HISTORIC AND DESIGN REVIEW COMMISSION

HDRC CASE NO: 2025-105
ADDRESS: 517 WICKES
LEGAL DESCRIPTION: NCB 2916 BLK 5 LOT 17
ZONING: RM-4, H
CITY COUNCIL DIST.: 1
DISTRICT: King William Historic District
APPLICANT: Stephanie FLORES
OWNER: Stephanie FLORES/FLORES STEPHANIES & JOE MARK
TYPE OF WORK: 2-story rear accessory structure construction
APPLICATION RECEIVED: April 23, 2025
60-DAY REVIEW: June 22, 2025
CASE MANAGER: Bryan Morales
REQUEST:

The applicant is requesting a Certificate of Appropriateness for approval to construct an approximately 950 sf rear 2-story accessory structure with a garage.

ELEVATIONS

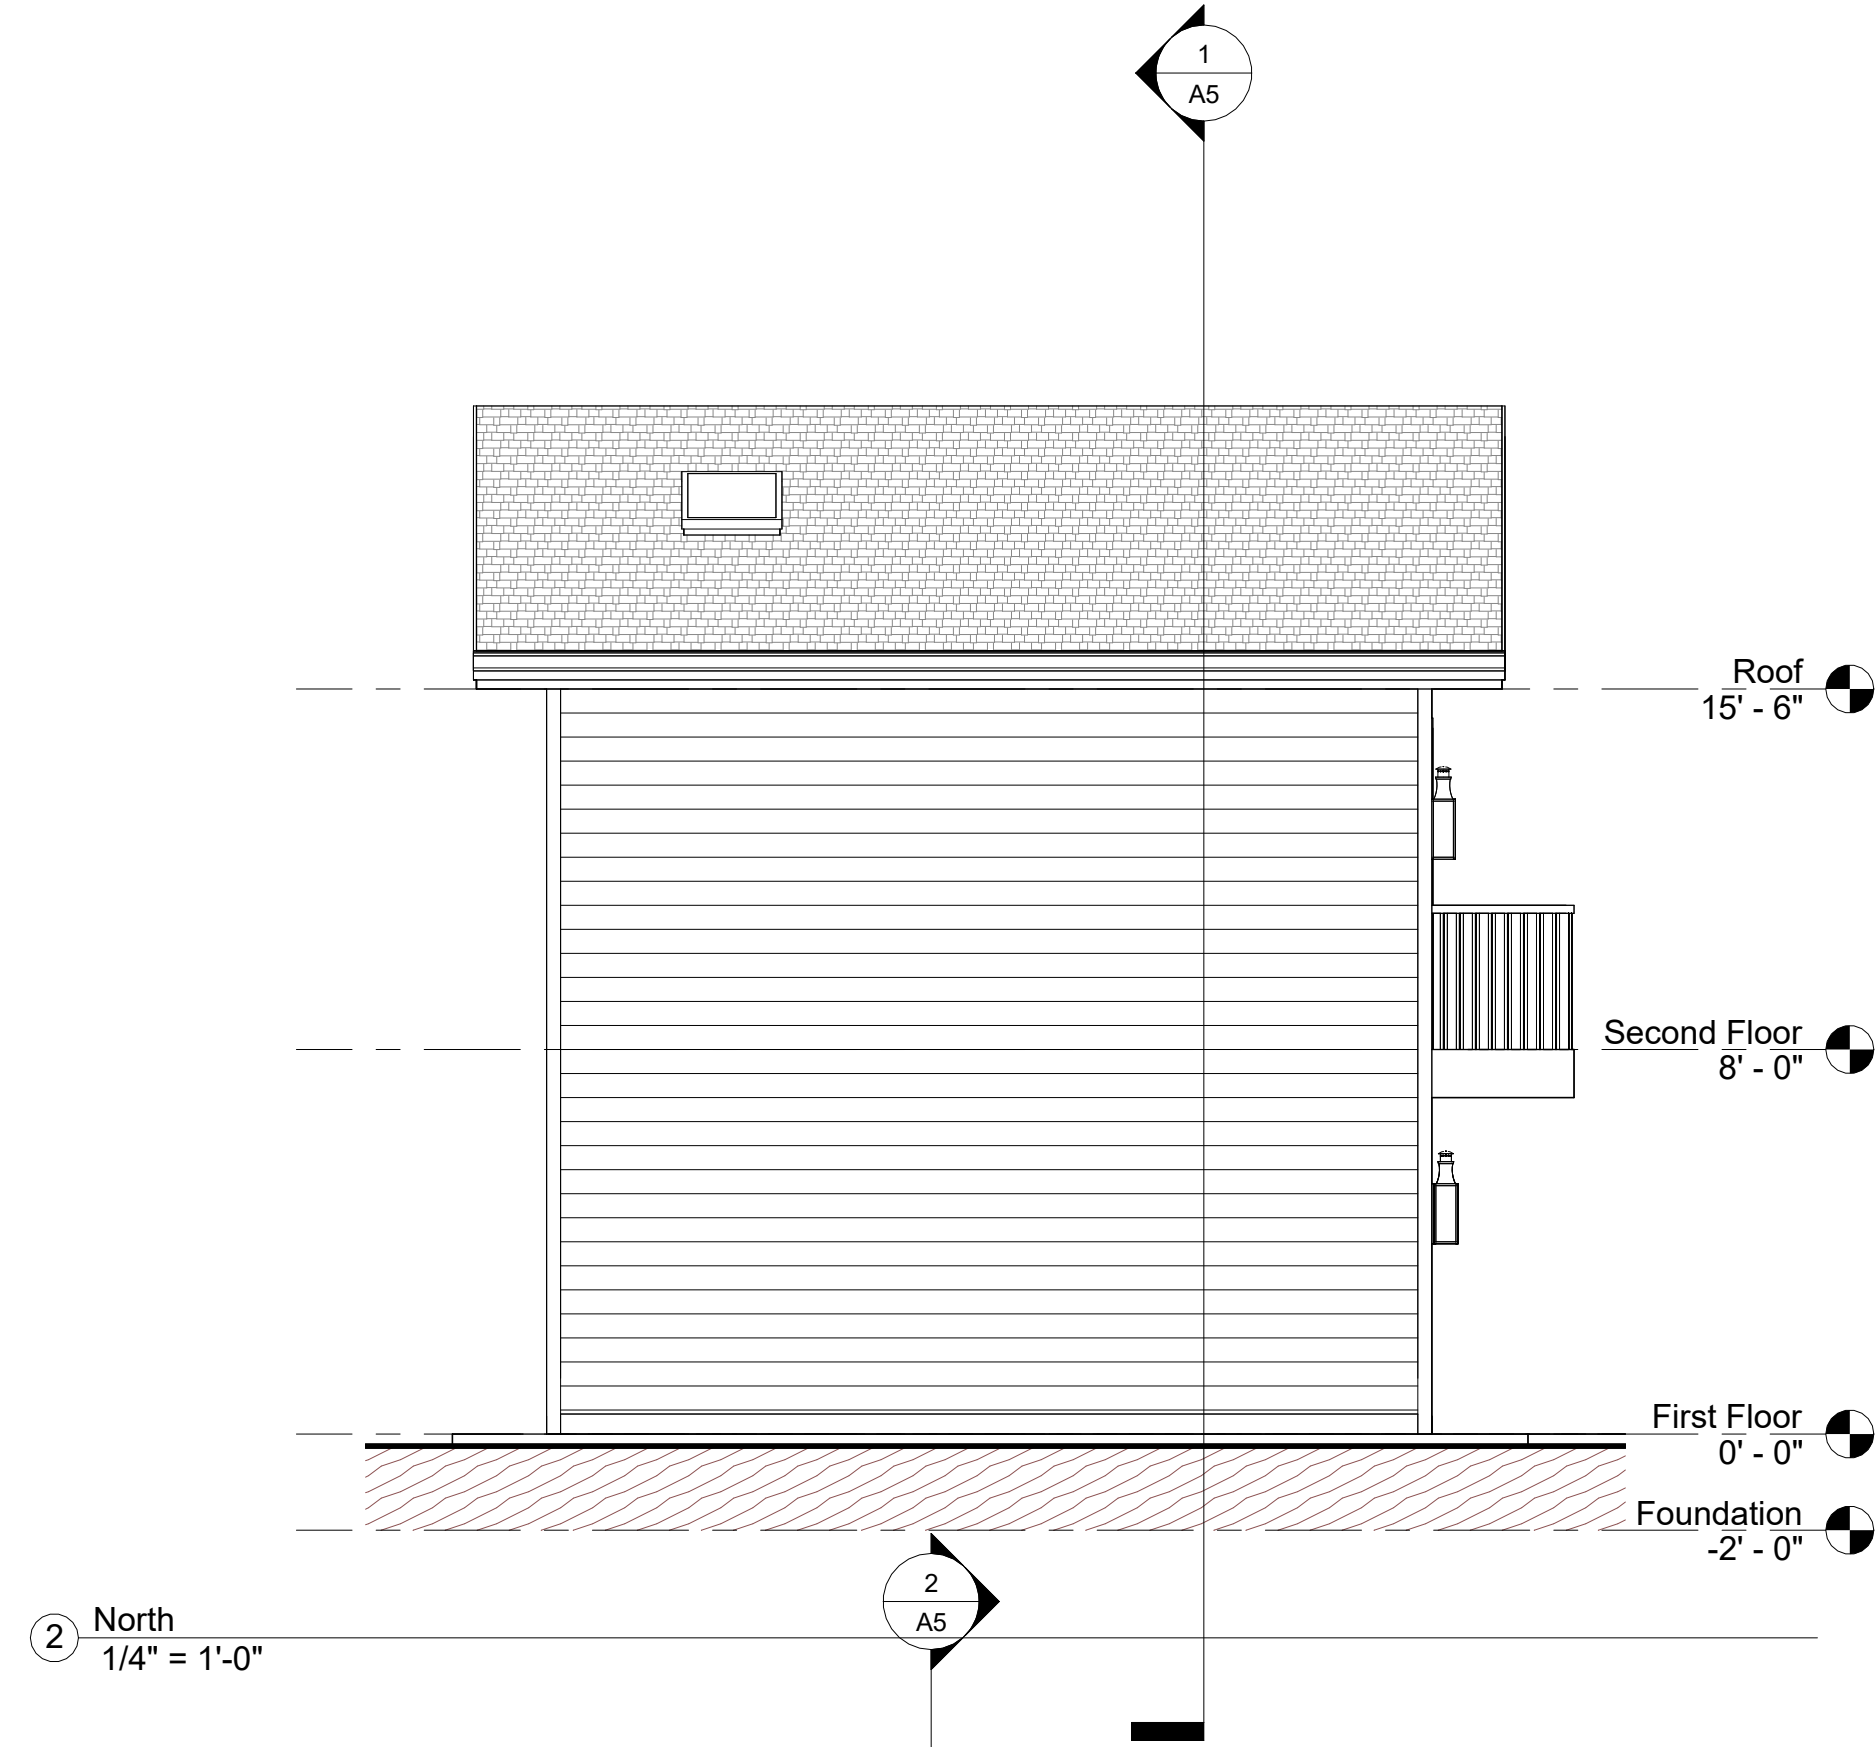
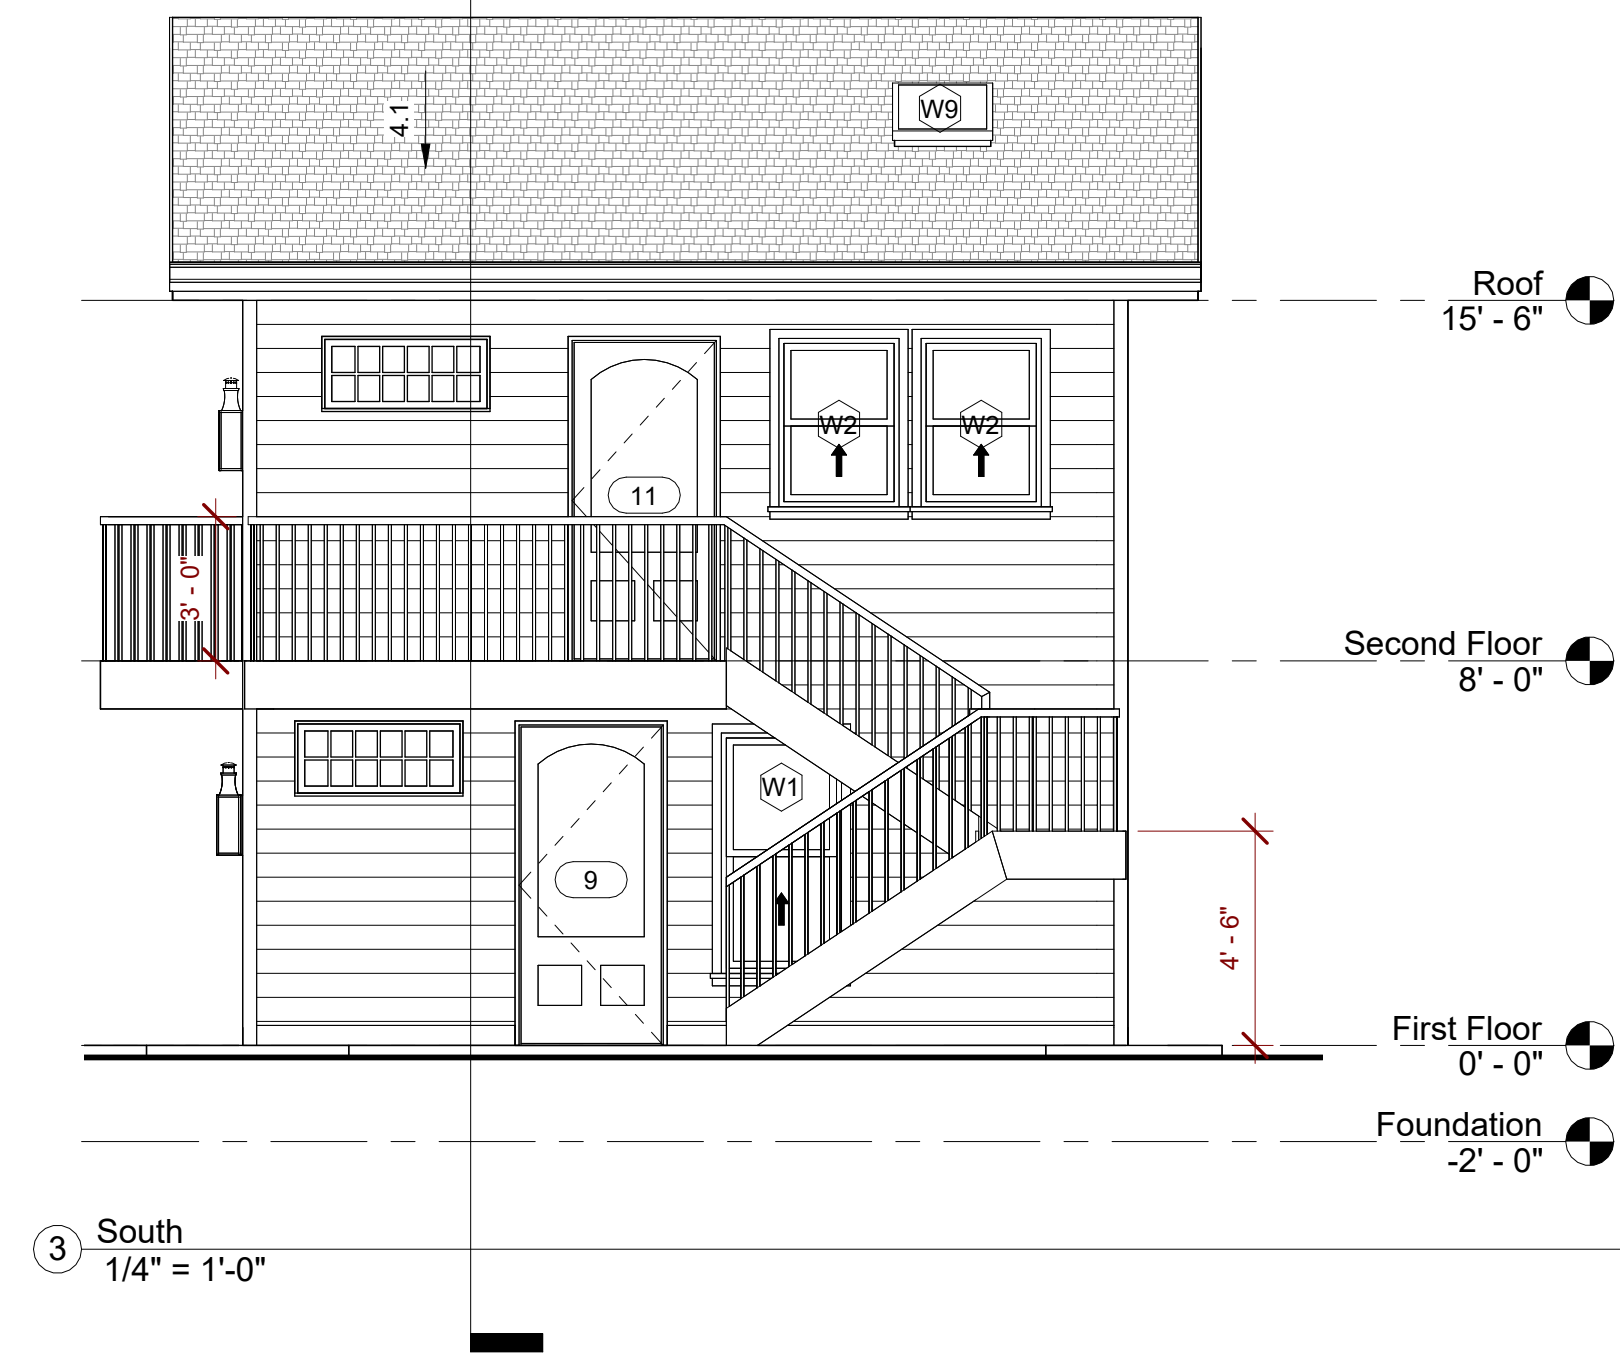
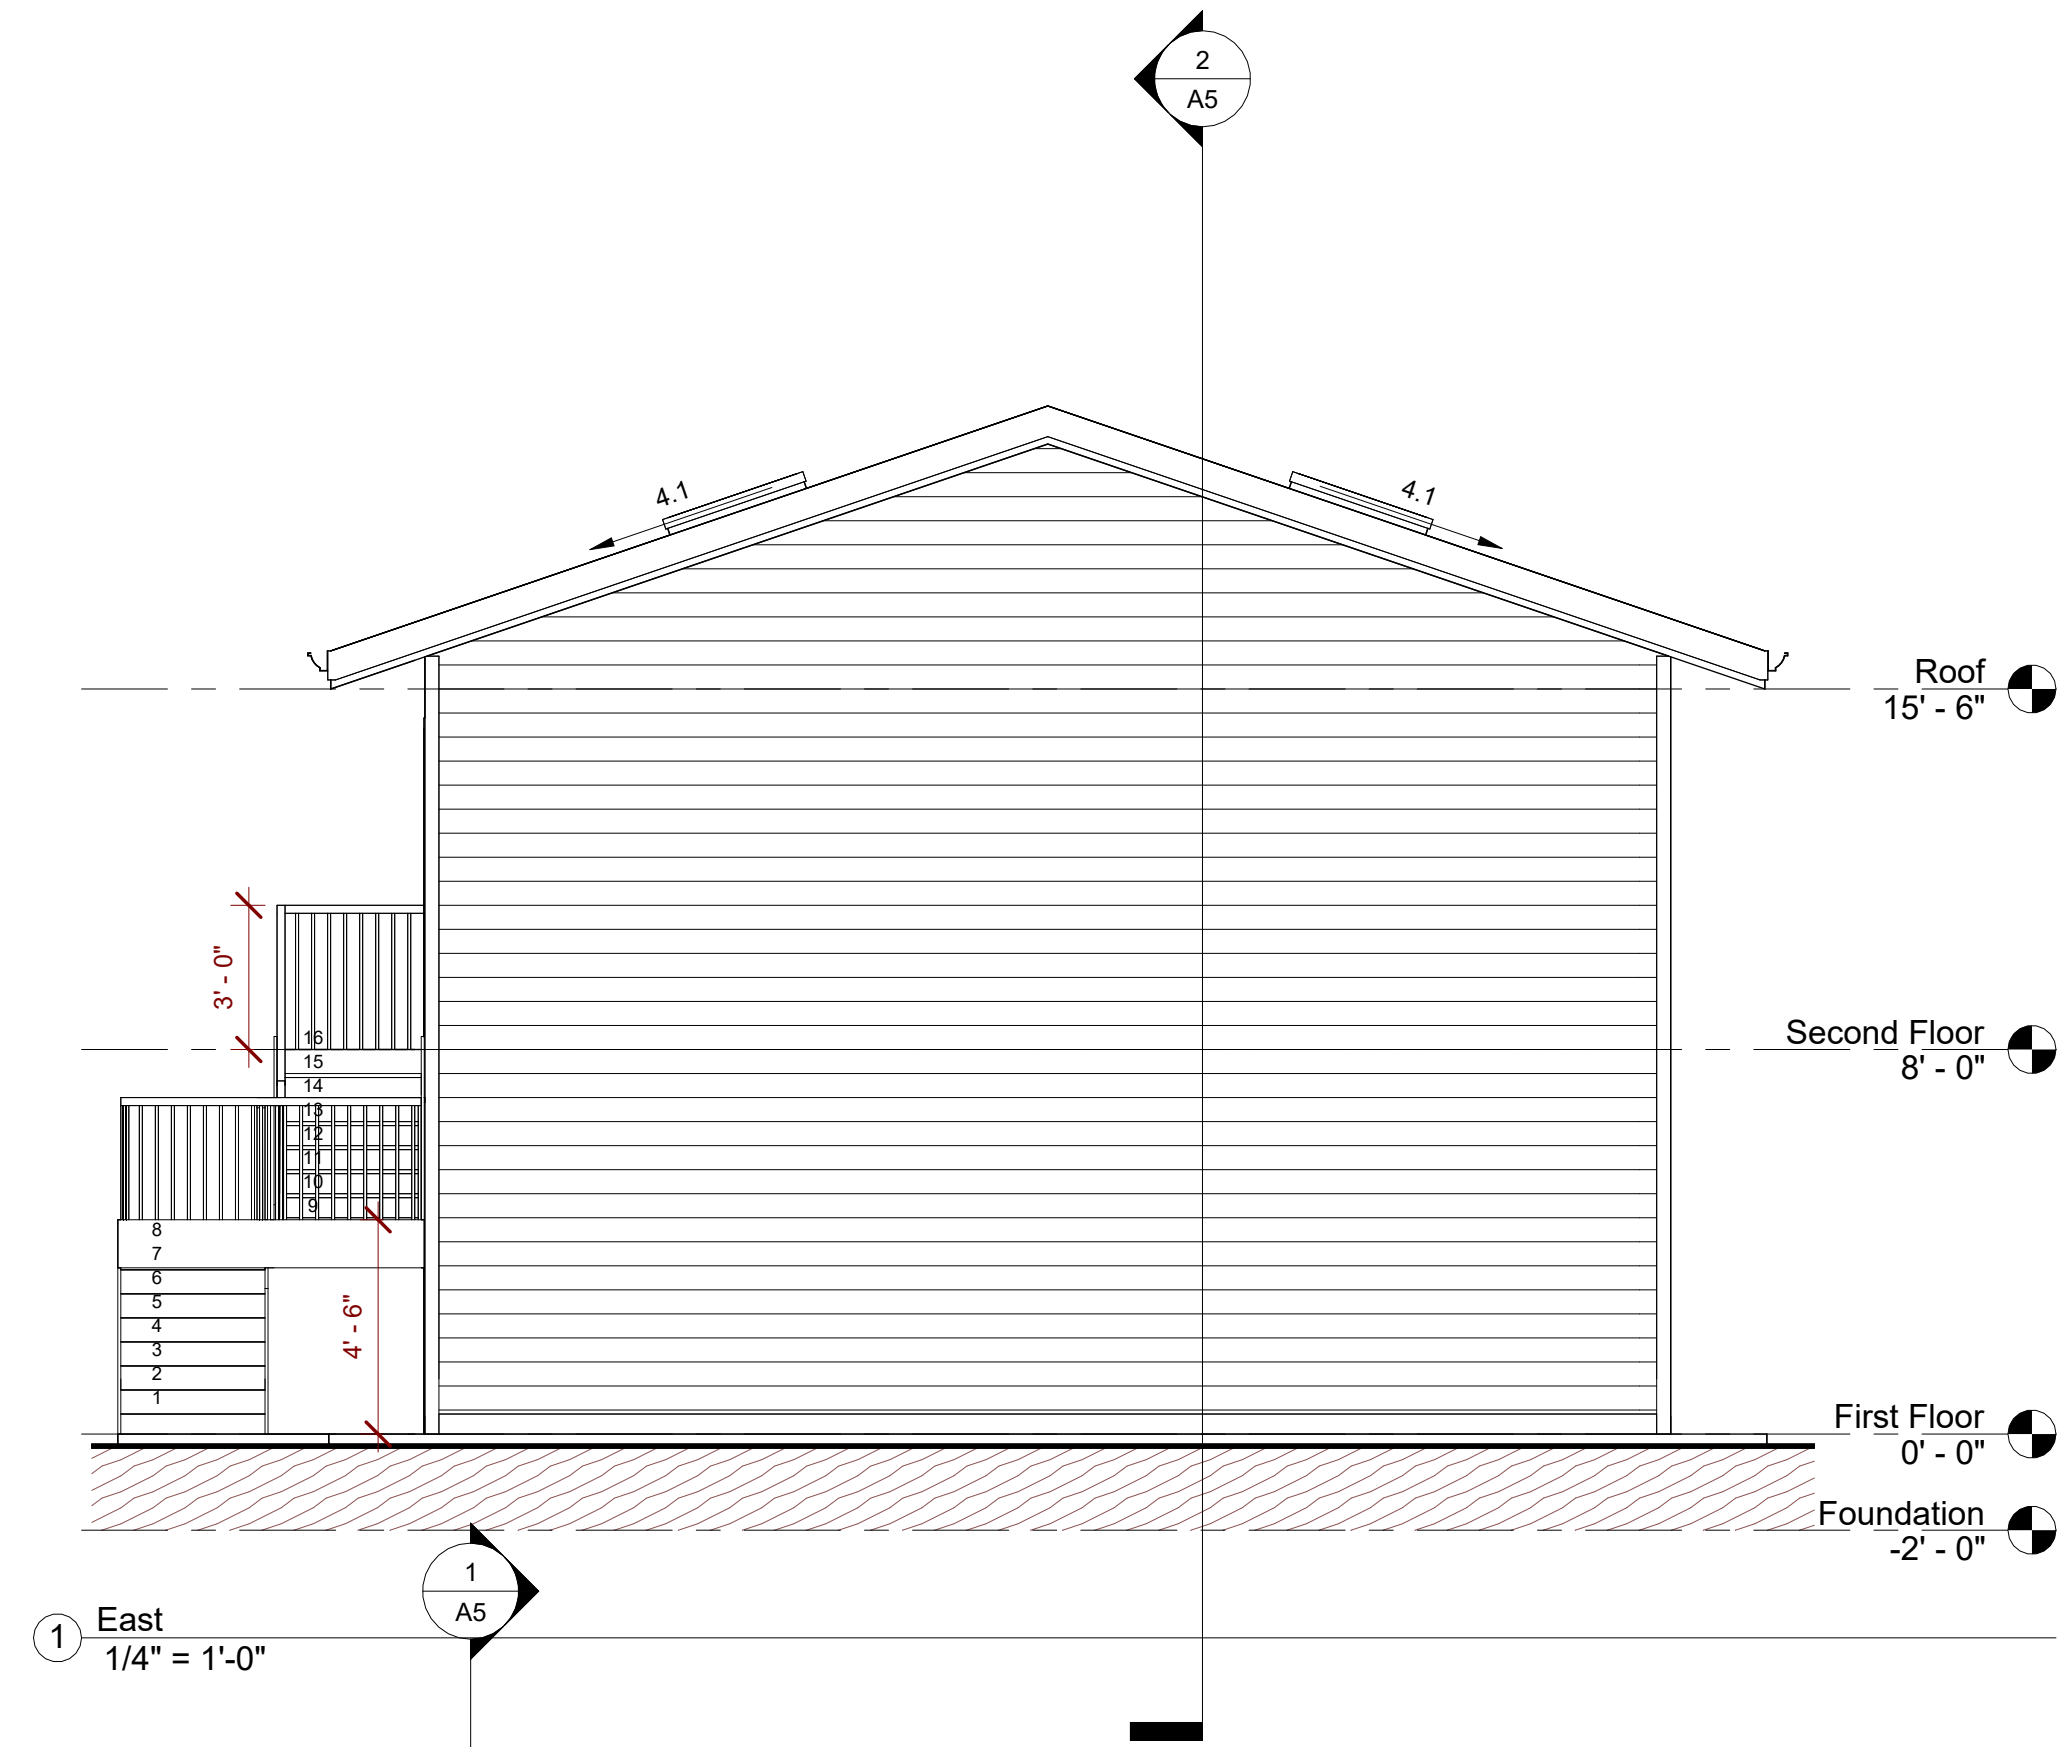
- h. ARCHITECTURAL DETAILS – The applicant is requesting approval to construct a 2-story accessory structure at the rear of the property featuring a single-bay with a 9’2” wide garage door facing the front driveway, lapped siding, one-over-one windows, four-over-four windows, two twelve-lite clerestory windows, two skylights, two porch areas, and an exterior staircase on the south side of the proposed structure. The Guidelines for New Construction 5.A.iii. and 5.A.iv. note that new accessory structures should relate to the period of construction of the primary historic structure on the lot by using complementary materials and simplified architectural details. Staff finds the proposed architectural details generally appropriate.

- j. ARCHITECTURAL DETAILS (FENESTRATION PATTERN) – The applicant is requesting approval to install one twelve-lite clerestory window, one door, and two one-over-one windows on the south façade’s second floor; one twelve-lite clerestory window, one door, and one one-over-one window on the south façade’s first floor; one four-over-four window and door on the west façade’s second floor; and one 9’2” wide garage door on the west façade’s first floor. New Construction 2.C.i. related to window and door openings stipulates to incorporate window and door openings with a similar proportion of wall to window space as typical with nearby historic facades. Staff finds the proposed fenestration pattern generally appropriate; however, the applicant should incorporate a consistent window style for the proposed rear accessory structure.

MS: For square-footage – I am concerned about the second story and it being taller than the primary structure. It should be secondary to the primary structure. Have you considered doing only 1 or 1.5 story? You could include a loft area. SF: Yes. For conceptual review, I offered a few different options, and those options included the different heights. I am here now for the design portion. I am fine with adjusting the height of the structure and reducing the plate heights. MS: Try lowering the entire roof and have a vaulted ceiling on the top floor. This could help bring it down. SF: We are dealing with space issues at the rear.

JF: One thing that would help with roof pitch, if the roof ridge ran the length of the house, then what is facing the front of the street would not be so much wood siding. This might be another quick study to see if it reduces the overall massing. MS: The original request did have side facing gables.

JF: If you turn the roof 90 degrees, look at the overhang of the roof and see how much you can get more roof coverage over that balcony. It would bring the strong horizontal line down which may help bring down the scale of the building.

- i. That the applicant installs a fully wood or aluminum-clad wood window that meet staff’s standard window stipulations and submits updated specifications to staff for review and approval. The windows should feature an inset of two (2) inches within facades and should feature profiles that are found historically within the immediate vicinity. Meeting rails must be no taller than 1.25” and stiles no wider than 2.25”. White manufacturer’s color is not allowed, and color selection must be presented to staff. There should be a minimum of two inches in depth between the front face of the window trim and the front face of the top window sash. This must be accomplished by recessing the window sufficiently within the opening or with the installation of additional window trim to add thickness. Window trim must feature traditional dimensions and architecturally appropriate sill detail. Window track components must be painted to match the window trim or concealed by a wood window screen set within the opening.

- ii. That the applicant install either wood siding matching the historic structure onsite or install lapped fiber cement siding featuring a smooth finish and not to exceed a 5” reveal.

- iii. That the applicant install a fully wood garage door or a garage door with a design that mimics wood construction and features a smooth finish without a faux wood grain texture. Final garage door specifications must be submitted to staff for review and approval prior to the issuance of a Certificate of Appropriateness.
